DATE: January 4, 2022

ADDENDUM NUMBER: 2

MODIFYING: Specifications No. 1873A

PROJECT: **La Verne Shops Building Completion – Stage 4**

Reference No.	Sheet No.	Drawing No.
1.	18	B-27182
2.	19	B-27183

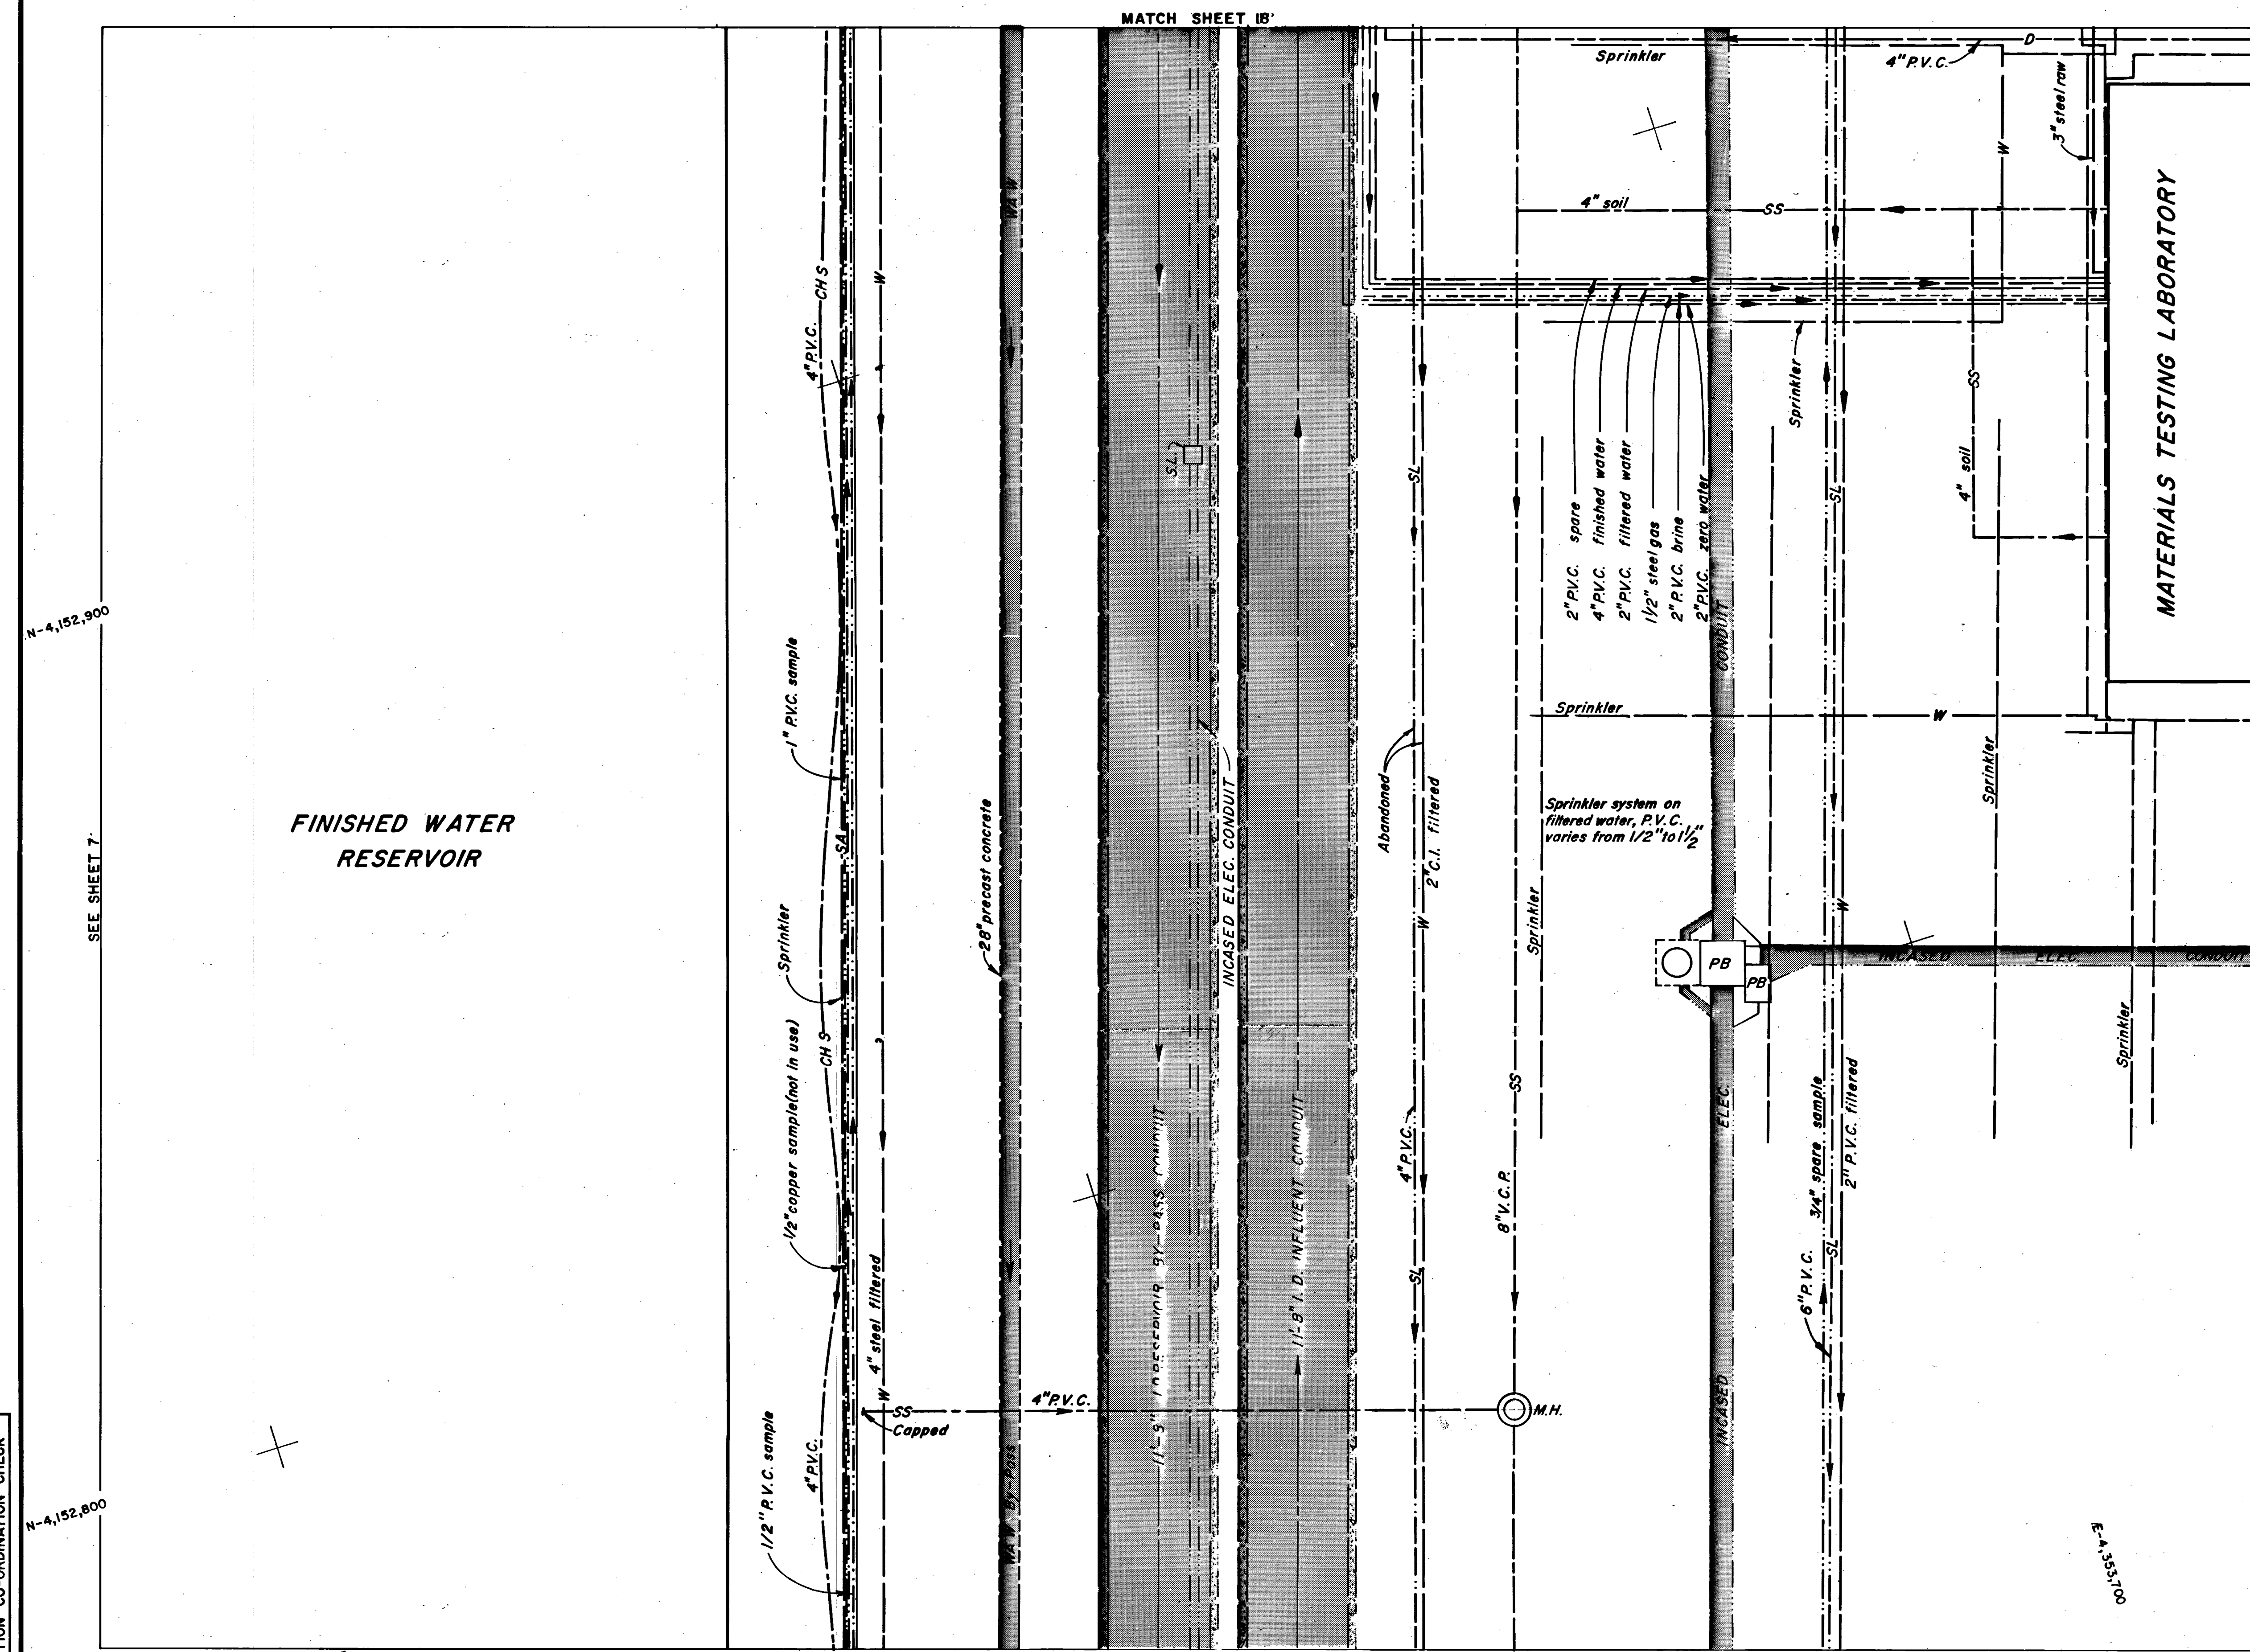
10. The following reference drawings are being provided for information. Prints of the reference drawings are attached.
